Amendment # 2

Approved Building Consent Document

TODD RESIDENCES - 53 EDWARD AVENUE - CHRISTCHURCH

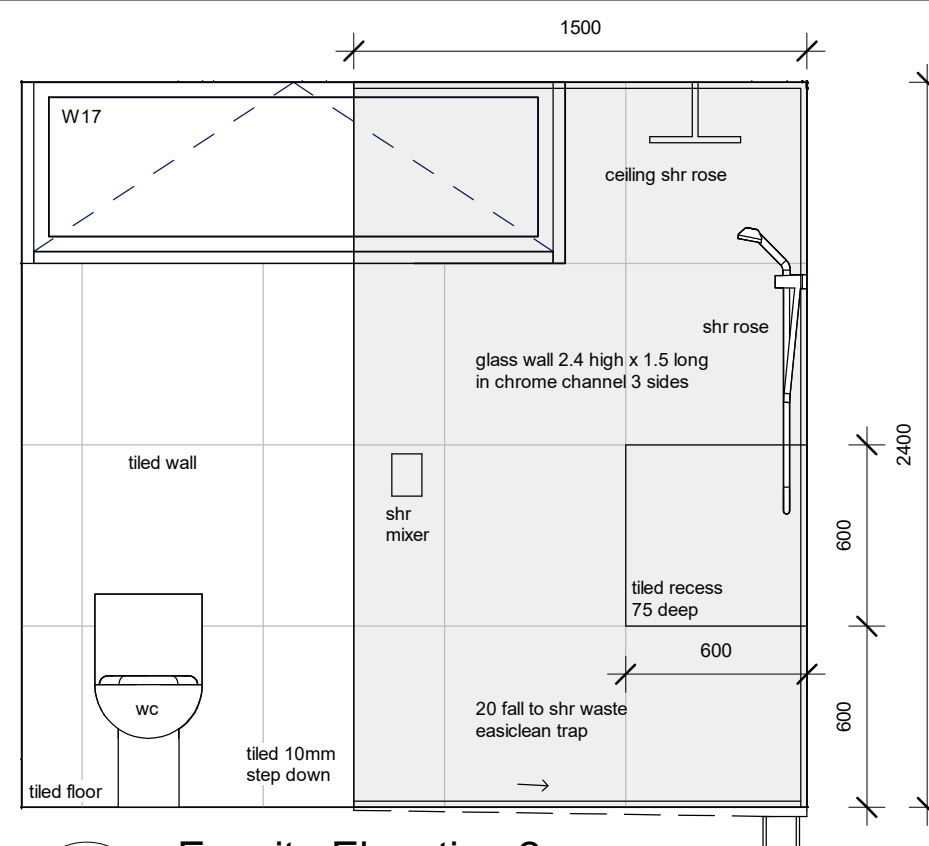
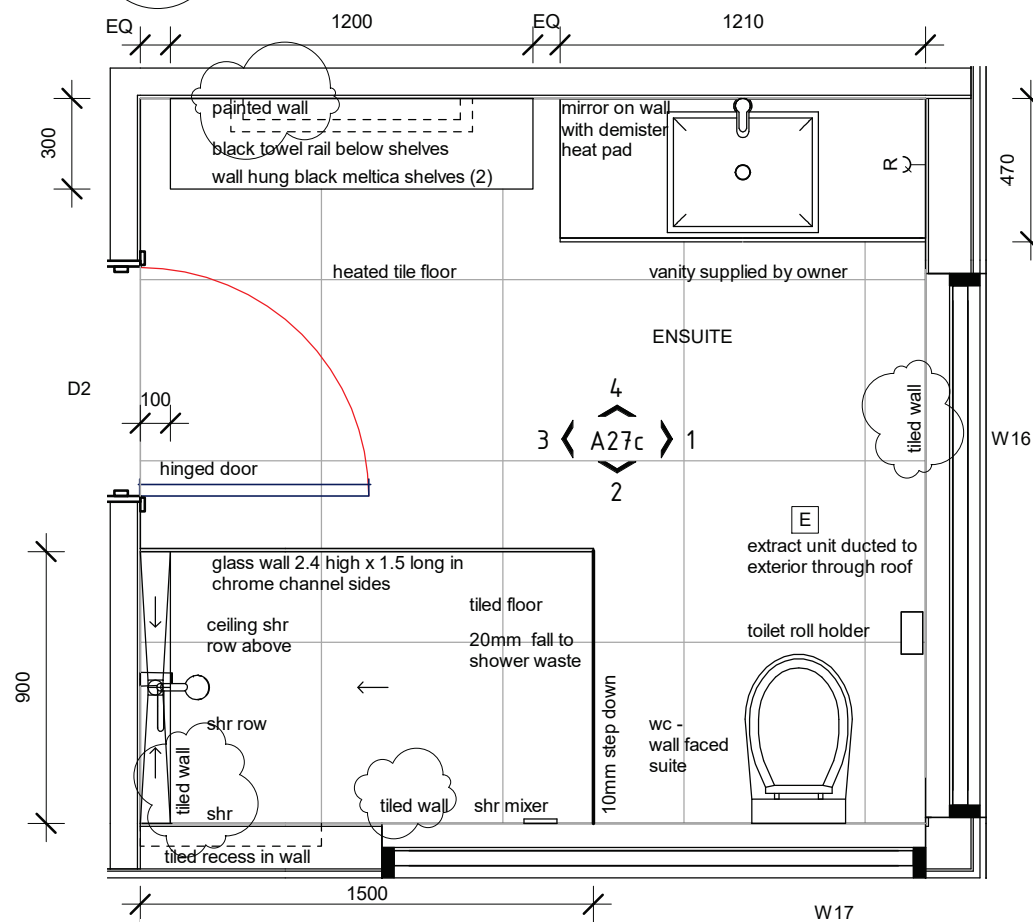
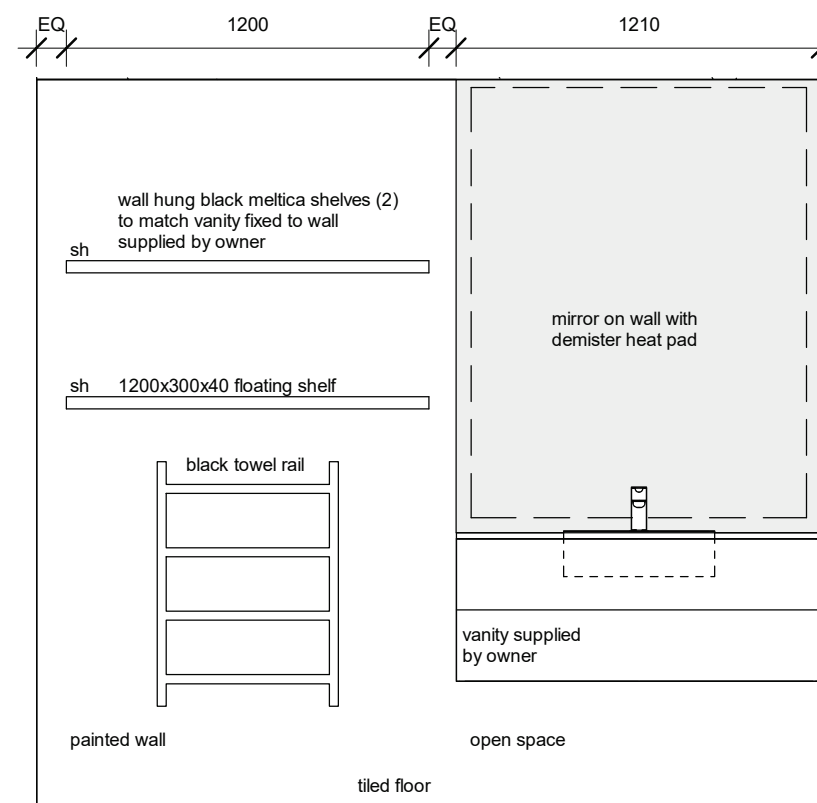
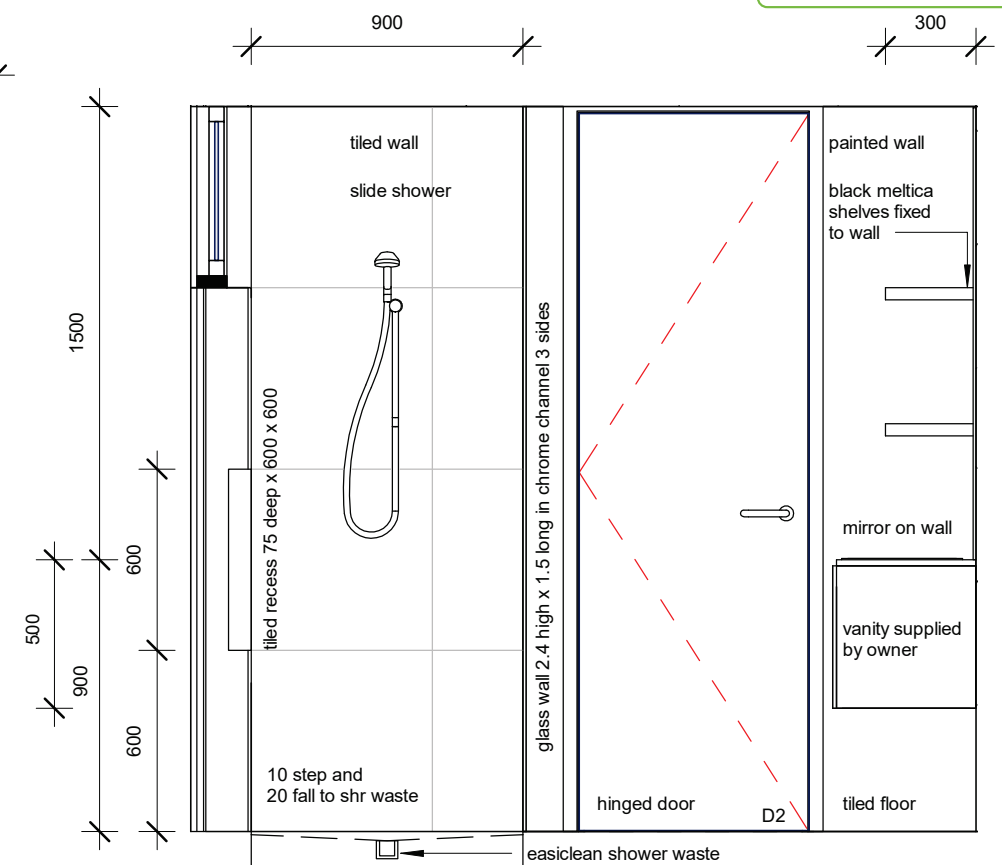
Amendment A - 30/04/18 Shower channels updated.

Amendment B - 30/05/18 Vanity unit changed.
 Amendment C - 17/06/18 Additional wall tiled.
